State of New Mexico
 Energy, Minerals and Natural Resources

WELL API NO. 30-015-22686
5. Indicate Type of Lease STATE <input type="checkbox"/> FEE <input checked="" type="checkbox"/>
6. State Oil & Gas Lease No.
7. Lease Name or Unit Agreement Name Williams Gas Com
8. Well Number: 1
9. OGRID Number 4323
10. Pool name or Wildcat Culebra Bluff; Atoka Gas

SUNDRY NOTICES AND REPORTS ON WELLS (DO NOT USE THIS FORM FOR PROPOSALS TO DRILL OR TO DEEPEN OR PLUG BACK TO A DIFFERENT RESERVOIR. USE "APPLICATION FOR PERMIT" (FORM C-101) FOR SUCH PROPOSALS.)	
1. Type of Well: Oil Well <input type="checkbox"/> Gas Well <input checked="" type="checkbox"/> Other	
2. Name of Operator Chevron U.S.A. Inc.	
3. Address of Operator 6301 DEAUVILLE BLVD., MIDLAND, TX 79706	
4. Well Location Unit Letter <u>C</u> : <u>560</u> feet from the <u>North</u> line and <u>1980</u> feet from the <u>West</u> line Section <u>25</u> Township <u>23S</u> Range <u>28E</u> NMPM County <u>Eddy</u>	
11. Elevation (Show whether DR, RKB, RT, GR, etc.) 2989' GL

Proposed TA WELLBORE DIAGRAM

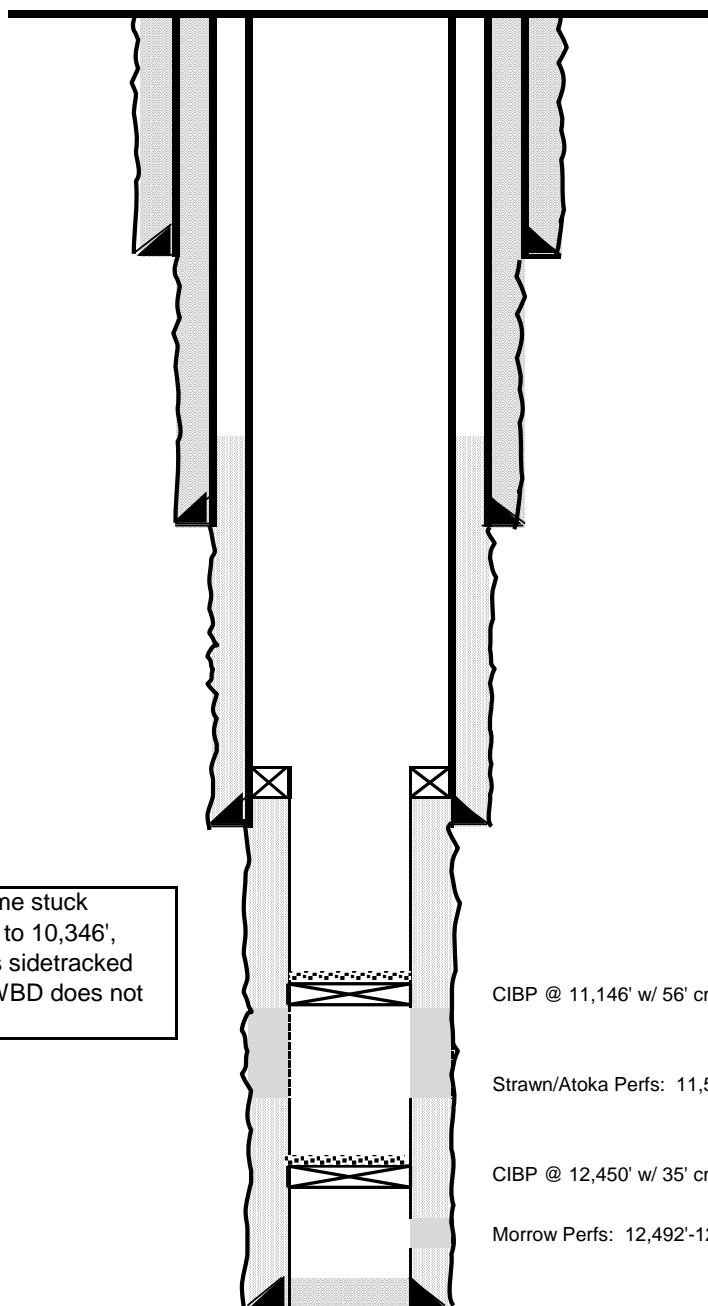
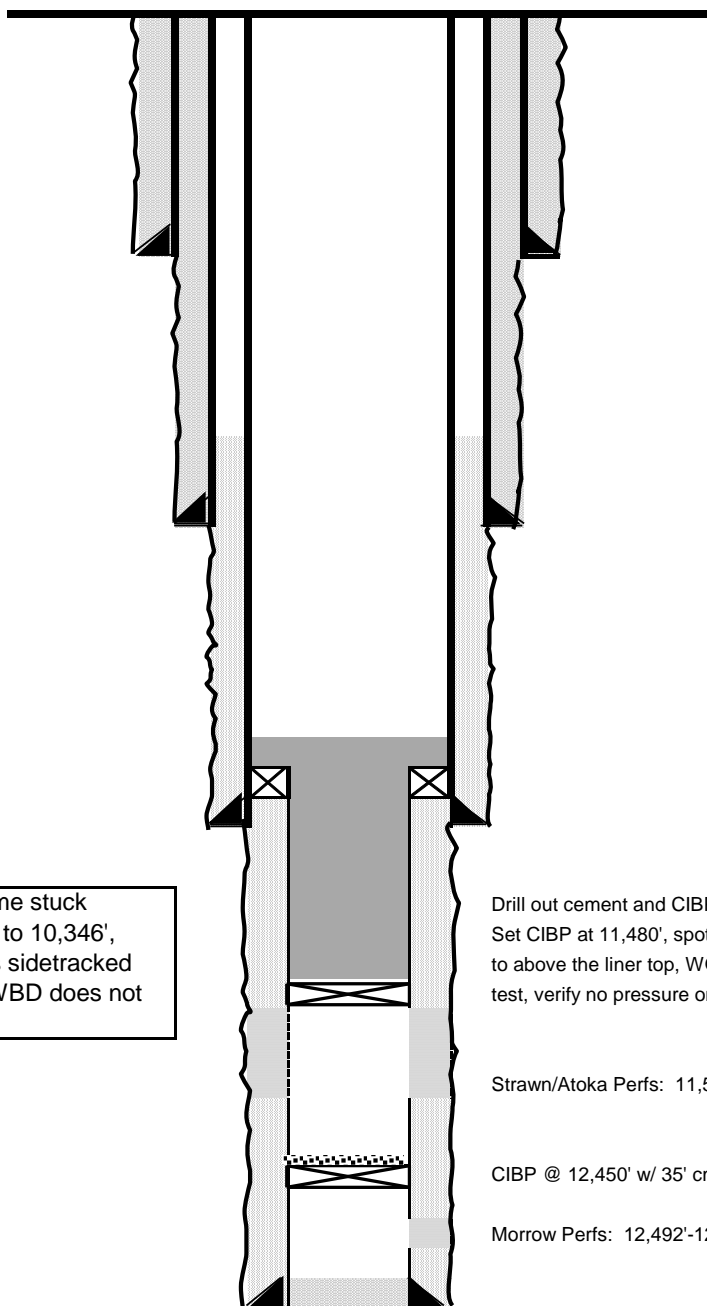
Drill out cement and CIBP at 11,146'
Set CIBP at 11,480', spot Class H cement to above the liner top, WOC & tag, pressure test, verify no pressure on the bradenhead

TA status may be granted for 6 months after a successful MIT test is performed. Contact the OCD to schedule the test so it may be witnessed.

Operator:	CHEVRON U S A INC	6301 Deauville Blvd	Midland, TX79706	OGRID:	4323	Action Number:	15005	Action Type:	C-103X
OCD Reviewer	Condition								
gcordero	Must pass a successful MIT
